Fuel Supply Module (FSM) Float Switch Replacement - 200/225/250/275 Verado

Models Covered	Serial Number Or Year
200/225/250/275 Verado	Model Year 2005
	Serial Number 1B152085 through 1B206576

FUEL SUPPLY MODULE (FSM)

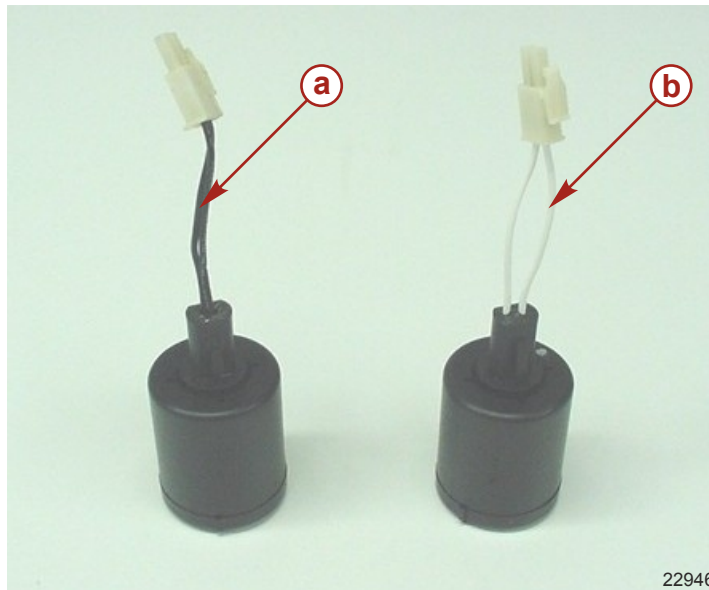
Prior to the removal/disassembly of the Fuel Supply Module, inspect the date code printed on the FSM tank. If the date code falls outside of the affected range, the FSM has been replaced and no further repair is necessary.

NOTE: Affected FSM date codes 5001 through 5153 must have their float switches inspected and/or replaced.

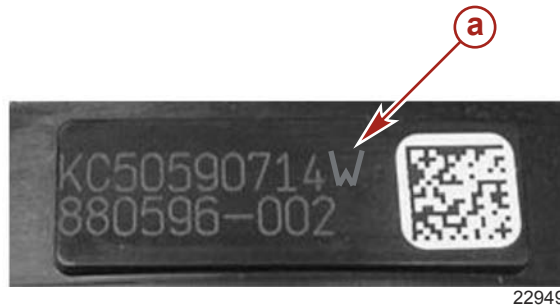
1. Use an awl to scribe a W into the FSM tank following the date code.

NOTE: W = Known good float switch (White wires)

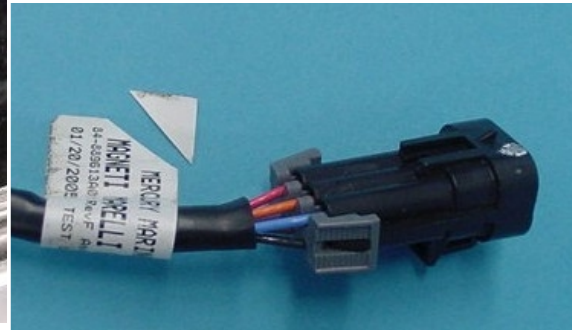
2. Cut off the non-text corner of the part number label of the fuel supply module harness. The label is secured around the FSM wiring harness and is routed just below the electrical box assembly. This identification marking is easily seen with the top/rear cowl removed.
